# ANGEL PLACE LEVEL 8, 123 PITT STREET SYDNEY NSW 2000

# KAMBALA SCHOOL SSD 10385 – VIA ADDENDUM

KAMBALA - VISUAL IMPACT ANALYSIS EXISTING MODELLED VIEW LOCATIONS

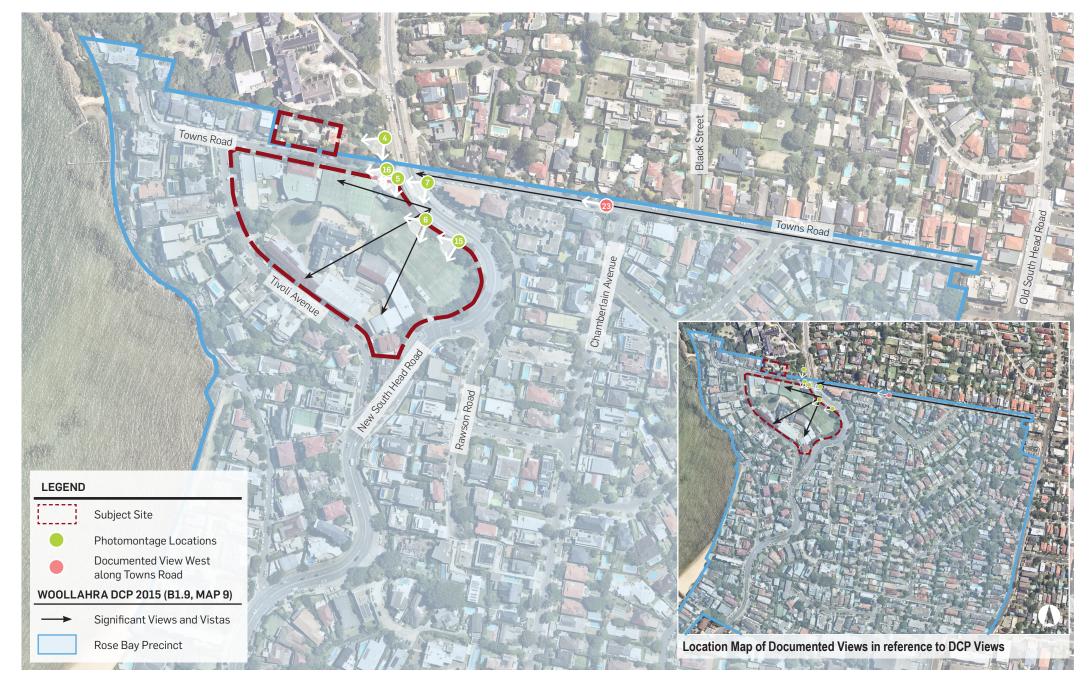
Use of the 3D model of the approved development for comparison of visual effects

Urbis inspected all public domain views and view places with RLA and selected photographs from each of those view places to be prepared as photomontages. The photomontages prepared include an Architectural 3D model of the built forms proposed (shown in a light grey colour block). For comparison the photomontages also include a 3D architectural model of a previously approved DA (shown as a yellow block). The inclusion of the previously approved development as shown in yellow is to demonstrate that a taller, bulkier development as approved could be constructed on the site.

In all views the approved taller, bulkier development is more visible ie creates a higher level of visual effects compared to the proposed development. The high level of external visibility and view blocking created by the approved development for example blocking a larger amount of the Tivoli House in public views is shown in photomontages 4, 5 and 6 from New South Head Road. In all cases the proposed development as modelled in grey creates a lower level of visual effects and when all relevant factors are considered a lower level of visual impacts on public domain views.
